<b>Title - Sujet</b> Surge Protective Devices 240V	
<b>Solicitation No. - N° de l'invitation</b> 08283-210015/A	<b>Amendment No. - N° modif.</b> 003
<b>Client Reference No. - N° de référence du client</b> 08283-210015	<b>Date</b> 2021-09-16
<b>GETS Reference No. - N° de référence de SEAG</b> PW-\$\$HN-478-80282	
<b>File No. - N° de dossier</b> hn478.08283-210015	<b>CCC No./N° CCC - FMS No./N° VME</b>
<b>Solicitation Closes - L'invitation prend fin</b> <b>at - à 02:00 PM</b> Eastern Daylight Saving Time EDT <b>on - le 2021-09-29</b> Heure Avancée de l'Est HAE	
<b>F.O.B. - F.A.B.</b> <b>Plant-Usine:</b> <input type="checkbox"/> <b>Destination:</b> <input checked="" type="checkbox"/> <b>Other-Autre:</b> <input type="checkbox"/>	
<b>Address Enquiries to: - Adresser toutes questions à:</b> Brazeau, Sean	<b>Buyer Id - Id de l'acheteur</b> hn478
<b>Telephone No. - N° de téléphone</b> (343) 574-2814 ( )	<b>FAX No. - N° de FAX</b> ( ) -

**Solicitation Amendment 003 is raised to address the following:**

1. To address questions submitted by potential bidders.
2. To amend Annex A – Statement of Requirement.
3. To amend Annex C – Mandatory Evaluation Criteria.

**Question 9.** ANNEX C – Item M1: Must have 2 PH split, 2 X 40mm 240V (2 X L-G), breaker.

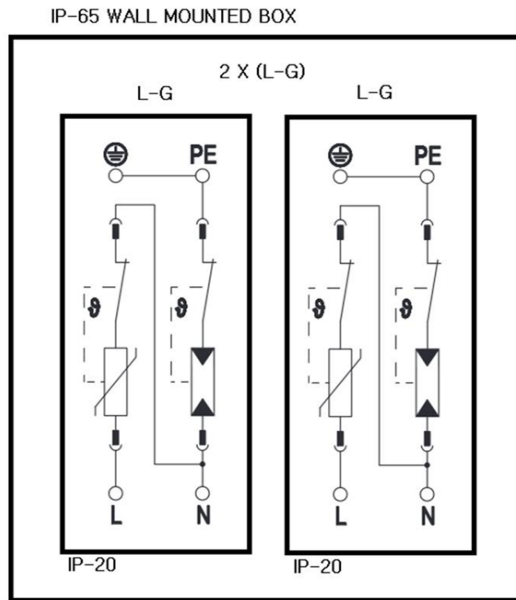
- What type of breaker do you need?
- Is it modular rail mounted or external wall mounted?
- What is your UPS main voltage?
- What is the earthing system? TT or TN-S, TN-C-S
- Could you please explain more and clarify about 2xL-G?
- Could you please clarify if the desired system is something like the below schematic diagram?

- Standard double pole breaker
- Wall mounted in a NEMA 4 or IP65 box.
- 240V unit must be able / compatible & certified to be used in all countries around the world: 208V (L-L), 220V (L-L), 230V (L-L OR L-N), 240V (L-L OR L-N)
- TT
- 2 surge protecting device (40mm MOV), each connected line-to-ground for worldwide application: 208V (L-L), 220V (L-L), 230V (L-L or L-N), 240V (L-L or L-N).
- Acceptable as long as MOVs are 40mm/140KA each. Multiple small MOVs in parallel to achieve 140KA per phase are not accepted.
